1966 Corvette: Service News: Wiring Diagrams for Breakerless Ignition Systems

Subject: Wiring Diagrams for Breakerless Ignition Systems

Source: Chevrolet Service News

Date: November 1965 - Volume 37 - Number 10

Fig. 6—Breakerless Ignition System—Chevrolet, Chevelle & Chevy II

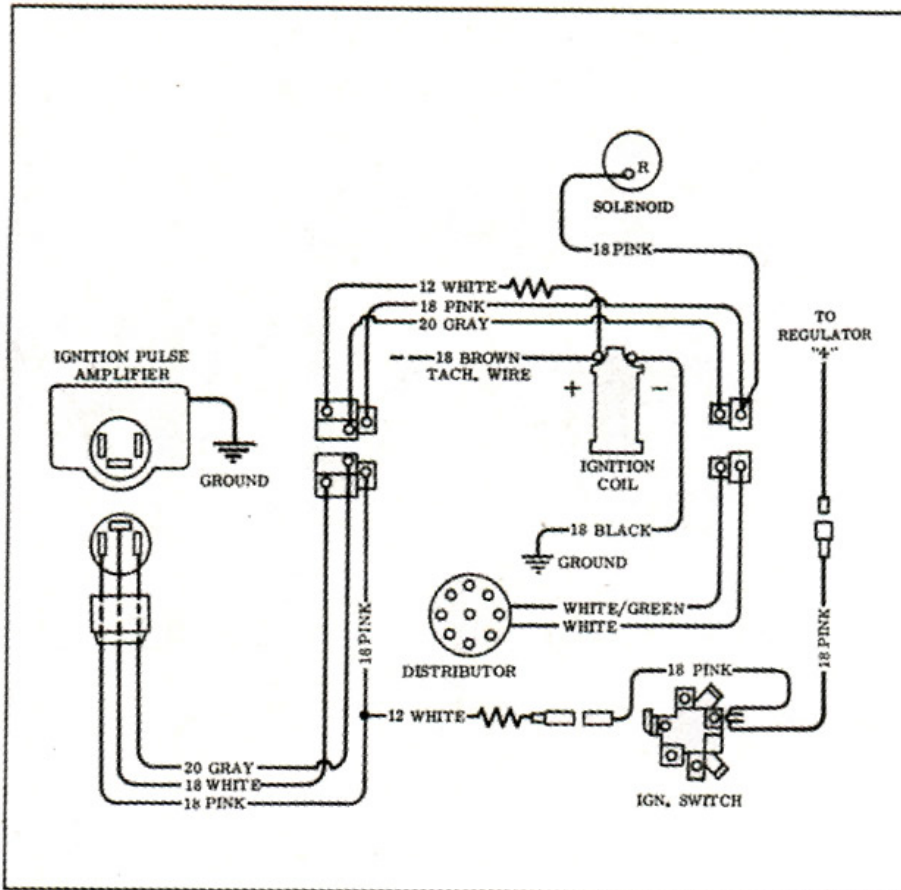
The following wiring diagrams for breakerless ignition systems superseded all other published diagrams for Chevrolet, Chevelle, Chevy II and Corvette.

The "12 white" is a calibrated resistance wire located on the negative side of the ignition coil on 1965 vehicles. However, in 1966 this resistance is placed on the positive side of the coil for added protection of the ignition pulse amplifier in case of accidentally grounding the ignition coil wire. At the present time, the above does not apply to trucks.
